### STAFF RECOMMENDATION 2404 Blair Boulevard March 18, 2020

**Application:** New Construction—Addition; Setback Determination  
**District:** Hillsboro-West End Neighborhood Conservation Zoning Overlay  
**Council District:** 18  
**Base Zoning:** RS7.5  
**Map and Parcel Number:** 10411033300  
**Applicant:** Jerry Turney  
**Project Lead:** Melissa Sajid, [melissa.sajid@nashville.gov](mailto:melissa.sajid@nashville.gov)

**Description of Project:** Application is to construct a rear addition with a setback determination to reduce the right-side setback from five feet (5') to three feet, six inches (3'-6"). The addition would be no closer to the property line than the historic house. The proposal also includes the addition of a window on the right-side façade of the historic house beyond the midpoint.

Figure 2. Proposed right-side façade with window opening to be added.

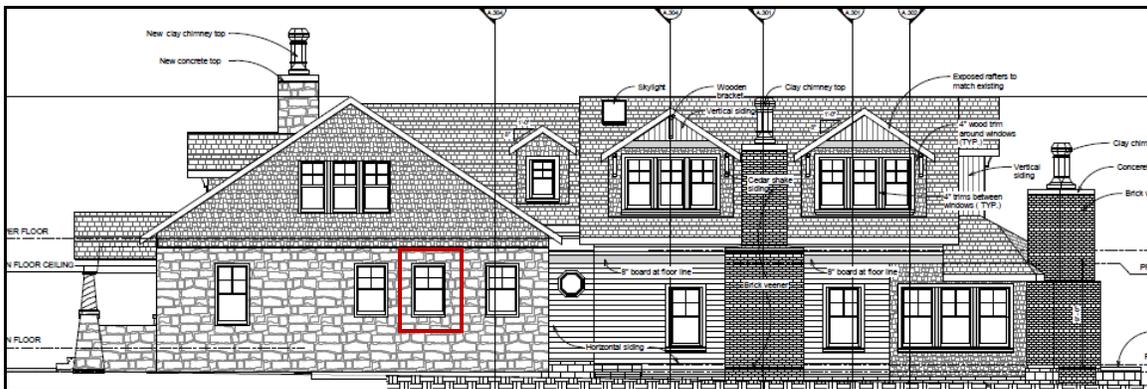
**Partial Demolition:** The applicant proposes to introduce a new window opening on the right-side façade (Figure 2). Staff finds that adding a new window opening can be appropriate given the location on the side façade beyond the midpoint and since the project does not include relocating or removing an existing window opening which can be more difficult given the historic stone cladding.

Staff finds that the proposed partial demolition meets Section III.B.2 for appropriate demolition and does not meet Section III.B.1 for inappropriate demolition.

2 PROPOSED RIGHT VIEW  
A.202 1/4" = 1'-0"

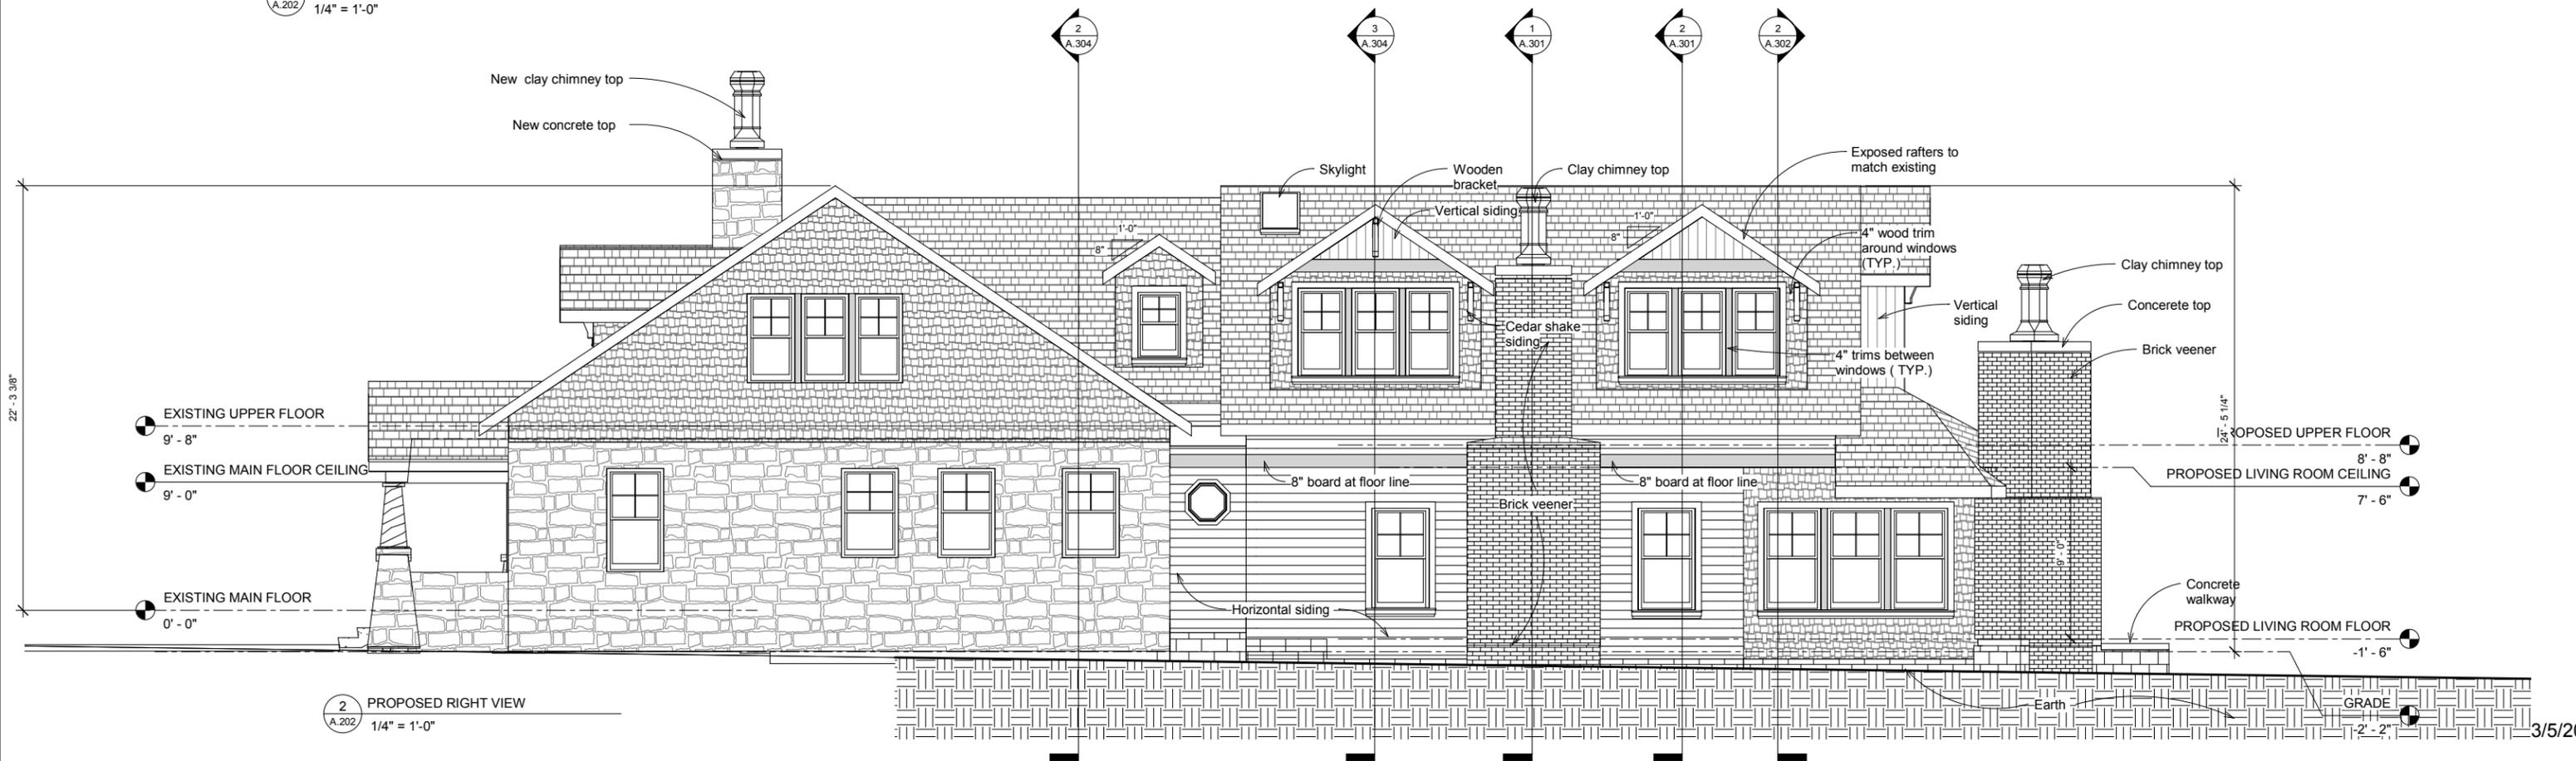
Roof form: The addition has a gable roof form with a pitch of 6.5/12. Gabled dormers with pitches of 8/12 are proposed on both side façades. All dormers will be inset two feet (2’) from the wall below. The roof pitch will be 6/12 to match that of the historic house. The addition includes three skylights on roof planes that will not be visible from the street. The project meets Section II.B.1.e.

Proportion and Rhythm of Openings: Most of the windows on the proposed addition are generally twice as tall as they are wide, thereby meeting the historic proportions of openings. The plan proposes four small octagonal windows; two are located on the rear façade, and one is located on each side façade in the alcove between the historic house and new addition. Staff finds that octagonal windows do not meet the proportions of historic windows but are appropriate in these locations since they are not likely to be visible from the street. There are no large expanses of wall space without a window or door opening. Staff finds the project’s proportion and rhythm of openings to meet Section II.B.1.g.

1. Staff approve the final details, dimensions and materials of the windows, doors, roof color, and siding material prior to purchase and installation;
2. Siding shall have a smooth finish with a maximum reveal of five inches (5”);
3. Staff approve the masonry color, dimensions, and texture; and,
4. The HVAC and utility meter shall be located behind the house or on either side, beyond the midpoint of the house. Alternative mechanical and utility locations must be approved prior to an administrative sign-off on building permit(s).
